Re: South Coast Rail, Proposed Wamsutta Layover Facility DEP File No. 049-0777

On October 17th, we received the peer review comments from the Commission's consultant, Nitsch Engineering (VHB provided a copy of the NOI and plans to Scott Turner at Nitsch on October 4th). This letter provides a written response to their comments: we hope that any issues can be resolved prior to the re-scheduled hearing on November 7th.

Catch Basin (CB) with Oil/Debris Trap - 2' Sump

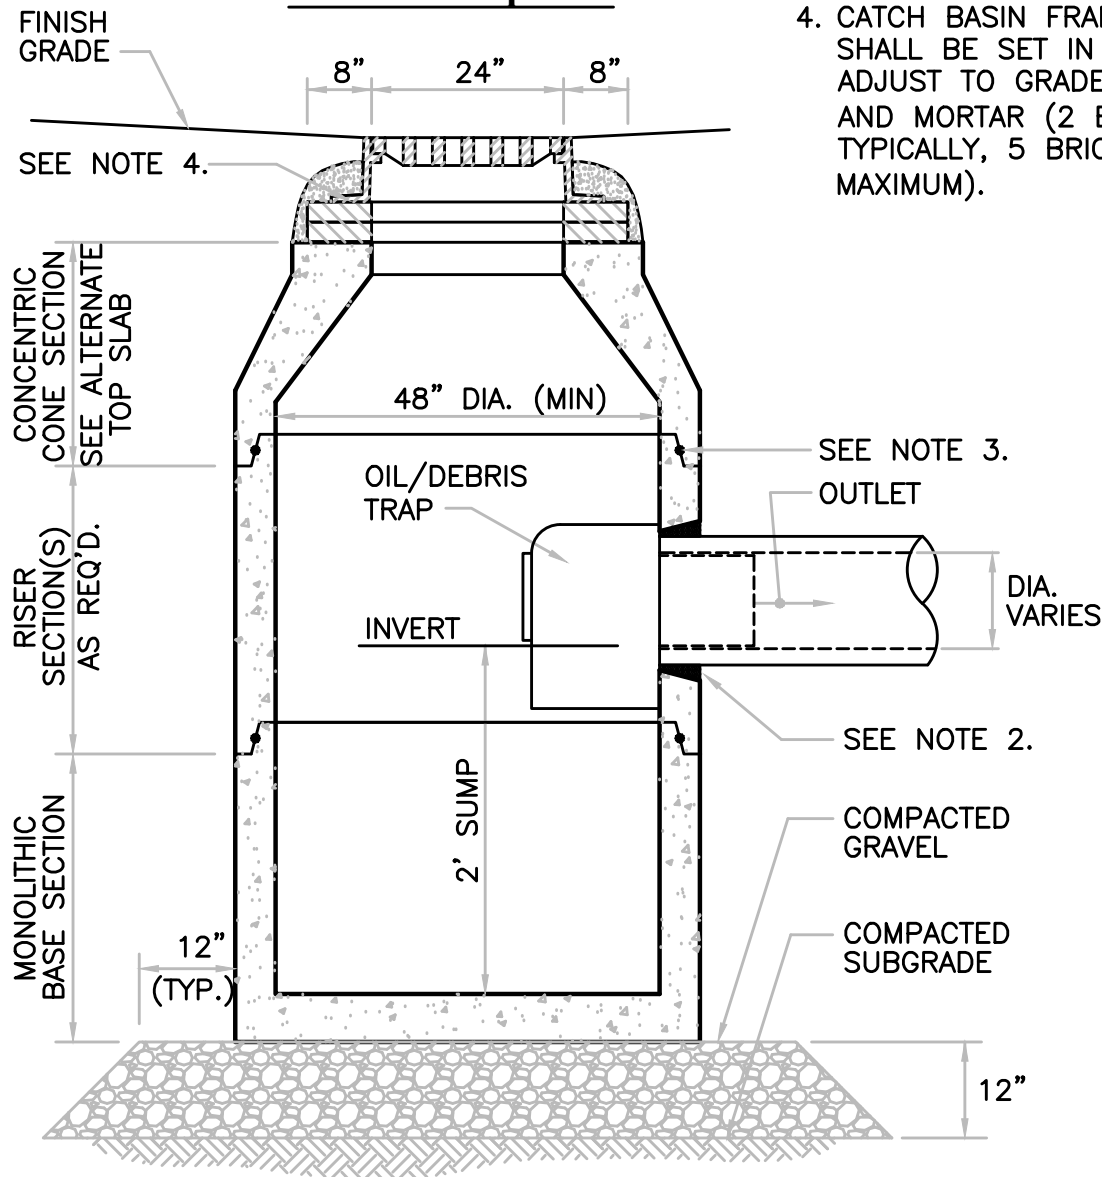
6. The proposed project includes catch basin to catch basin connections along the drain lines between the tracks. Typically, catch basin to manhole connections are installed to prevent sediments collected in the catch basin sumps from being re-suspended.

The access roadways between the layover tracks will have light traffic and the sumps will be cleaned by the MBTA. Due to the cap under most of the site the project is proposing catch basins with 2-foot sumps. A detail for these catch basins is attached. The collection system design is consistent with MBTA standards for this type of facility. Access roads are intentionally graded to drain to the center of the access road and away from the track. Installation of a drainage trunk line with catch basin laterals would have to be to the side and too close to the track ballast, resulting in an unbalanced collection of stormwater that filters through the ballast.

Grass Channel Section

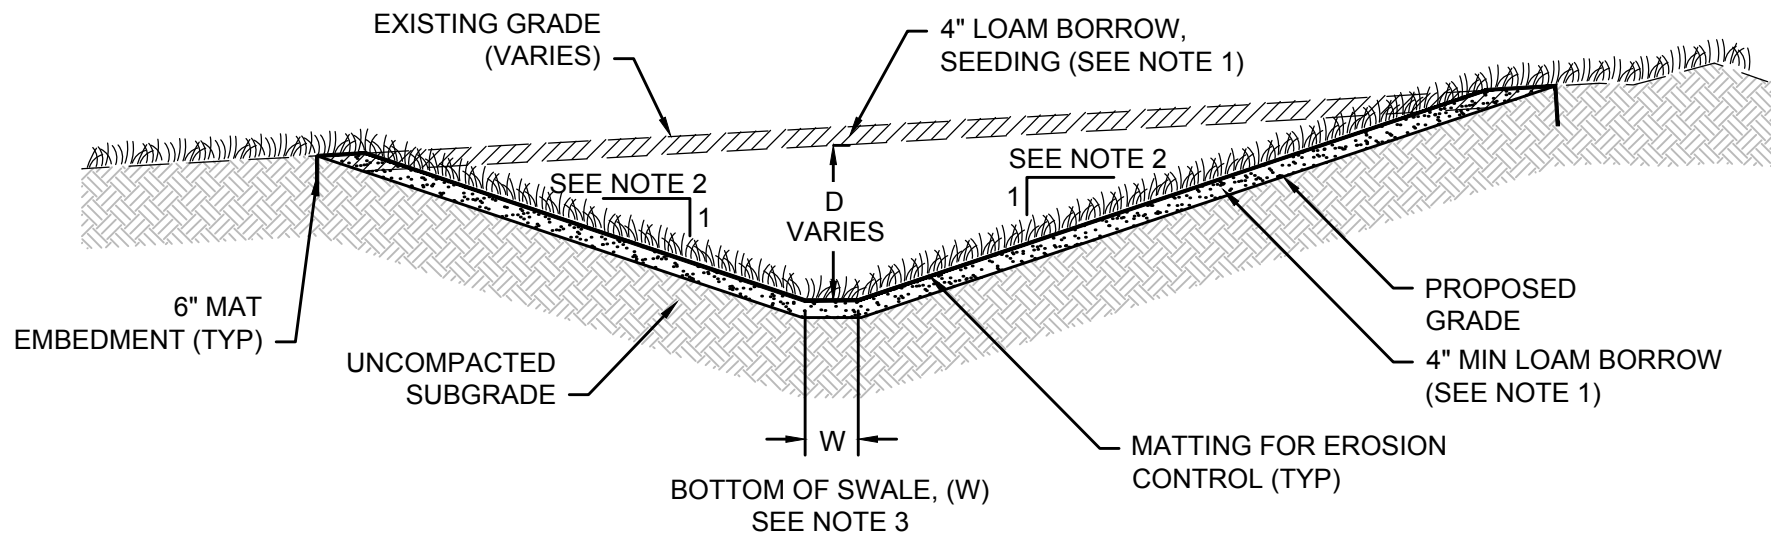
11. A grass channel is described as a Low Impact Development measure in the stormwater checklist. There is no detail for the grass channel or location shown on the plans.

The plans show this feature labeled "ditch" and "water quality swale" (see sheet CV-304). A detail for this grass channel is included in this response.
